# PRODUCT CHANGE NOTIFICATION

## Bourns® Model SRN6045 Series Semi-shielded Power Inductors

### Package Tape Carrier Modification

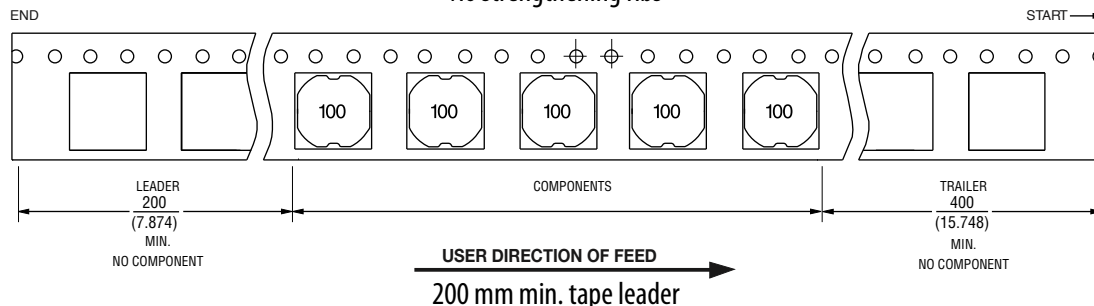
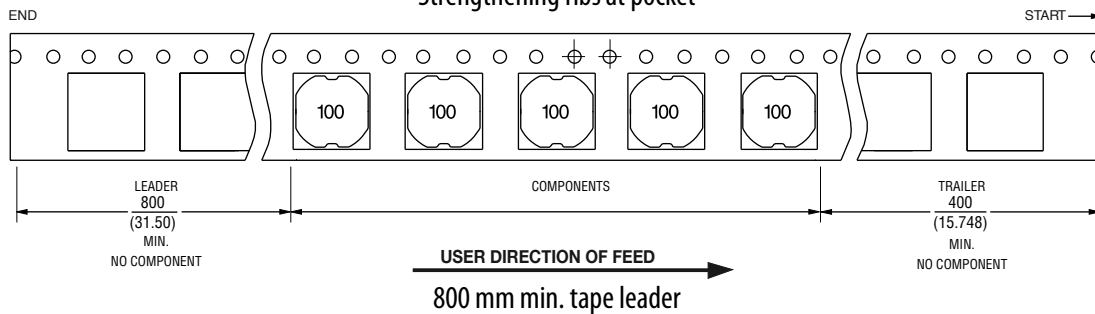
Riverside, California – July 27, 2021 – In the spirit of continuous improvement, effective January 22, 2022, Bourns will change the design of the package tape carrier for the [Model SRN6045 Series Semi-shielded Power Inductors](#). The design change will include strengthening the ribs to the carrier pocket to better protect the contained component from damage during freight transit and handling and lengthening of the tape leader. A list of affected part numbers follows.

No strengthening ribs

Strengthening ribs at pocket

The form, fit and function of the inductor will not change as a result of these changes to the package tape carrier. The quality and reliability of the inductor should be improved with these changes to the package tape carrier.
